Proposal for amendment to ECE/TRANS/WP.29/GRSP/2012/5
(Regulation No.44 Child Restraint Systems)

II. Comments

Base of the type of CRS where, once the main body is fixed on the base, the ISOFIX lock cannot be released unless the main body is removed from the base

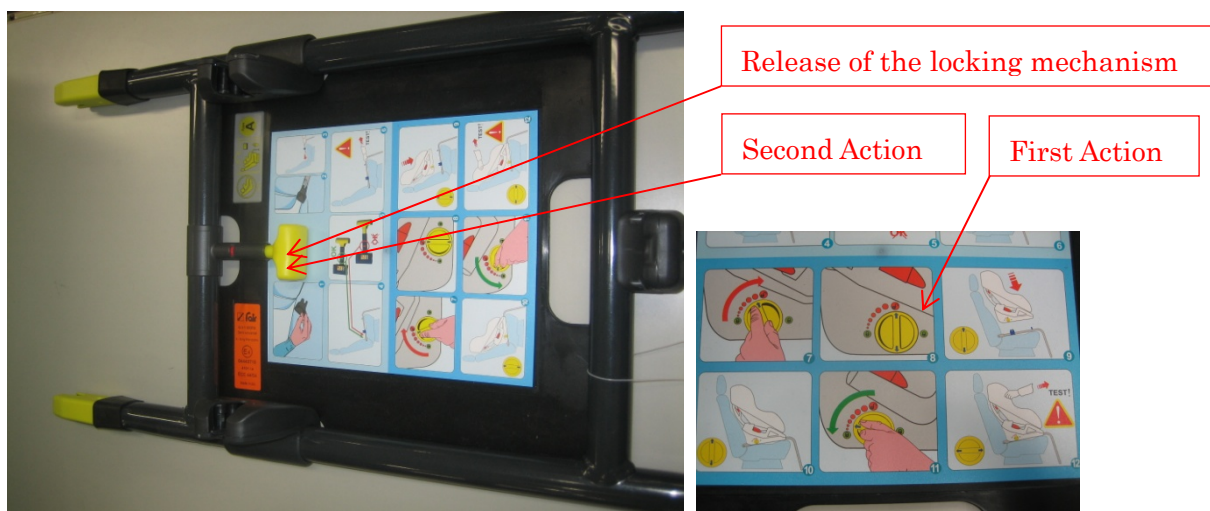
1. Among the ISOFIX-compatible CRSs, there are a number of types where the main body can be separated from the ISOFIX base. In some of these types of CRSs, the locking of the ISOFIX base and anchor points cannot be released unless the main body is removed from the ISOFIX base first.

In the case of this type of CRS, it will be extremely difficult for a child to release the lock of the ISOFIX base even if the two consecutive actions or the attachment opening force of at least 40 N is not required to release the lock. It is therefore deemed that this type of CRS meets the requirement equivalent to Paragraph 7.2.7.

However, as the possibility of users or their siblings releasing the lock of the main body cannot be eliminated, we believe that separate provisions on how much force is needed to release the main body locking mechanism and how to operate such lock/release mechanism should be established for the purpose of preventing improper operations at the main body and the ISOFIX base.

2. The geometry of the lever/hook for releasing the ISOFIX locking mechanism or of the ISOFIX base and their operational procedures vary among CRSs.

In some ISOFIX-compatible CRSs, the ISOFIX attachment opening force cannot be measured according to the provision of Paragraph 8.2.9.2. Therefore, the provision should be amended to allow a part that hinders the measurement to be removed or partially cut as long as such removal or cutting does not affect the ISOFIX attachment opening force.

Furthermore, we believe that detailed requirements on the hook geometry should not be provided and instead it should be allowed to use a hook with which the ISOFIX attachment opening force can be measured when the dynamometer or similar device is operated as indicated in the user's manual.

With the provision of Paragraph 8.2.9.2., measurement in operation as indicated in the user's manual may become difficult in some products. In this case, use of a hook of the geometry that enables such measurement should be allowed.

A part of the product that comes in contact with the dynamometer or hook should be removed or partially cut so that the attachment opening force can be measured.
